GE Nuclear Energy

Project 717

MFN 03-115
October 13, 2003

Subject: **Response to Request for Additional Information (RAI) numbers (117.2, 306, 314.1, 322, 323.4, 329, and 406) for ESBWR Pre-application Review - Supplementary Information**

Supplementary Information for RAI 117.2

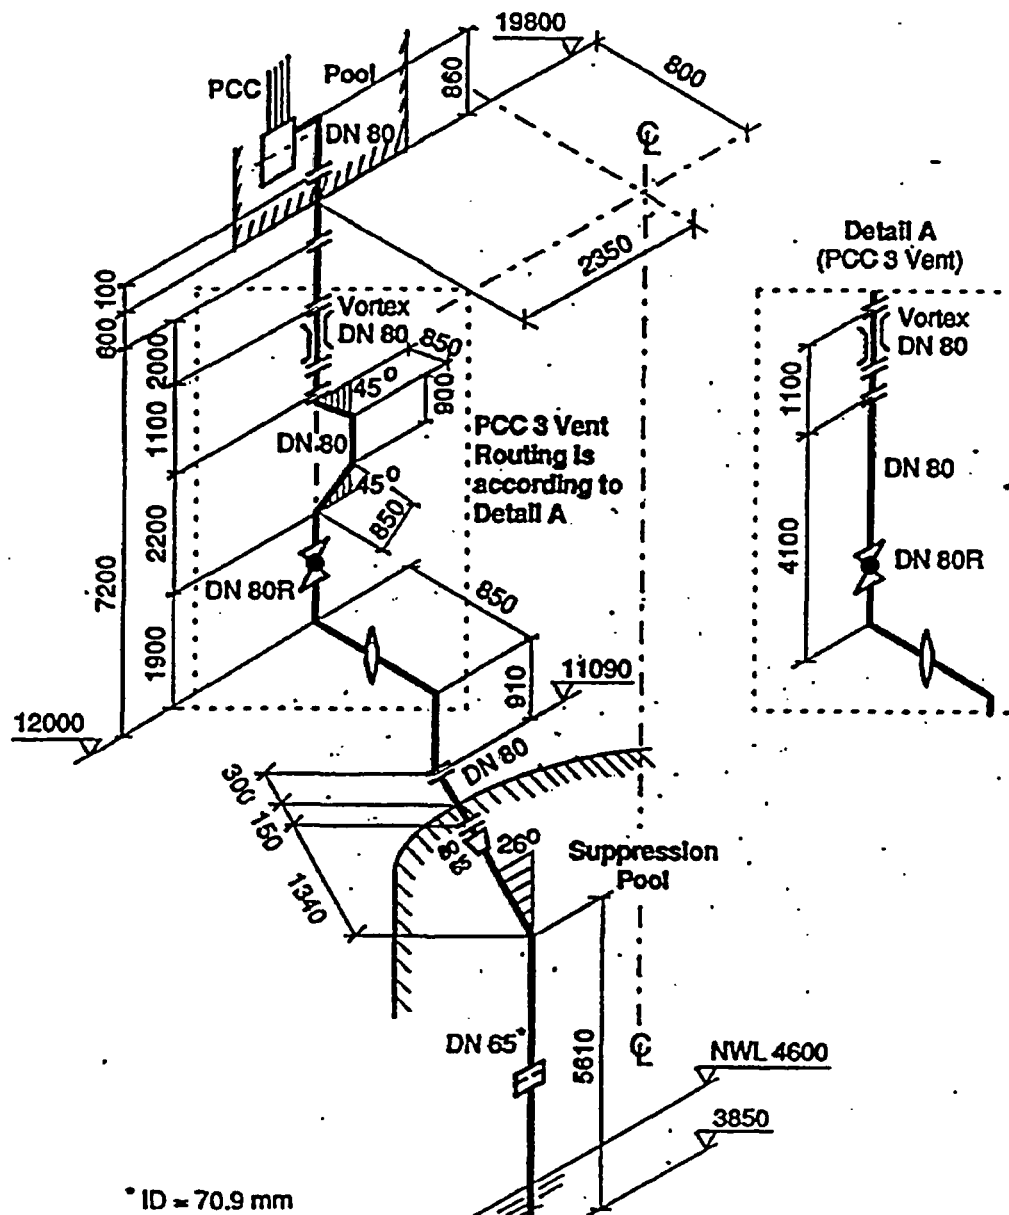
PCC Vent Pressure Tap – Located on downstream side of vortex flow meter

PCC Vent Line
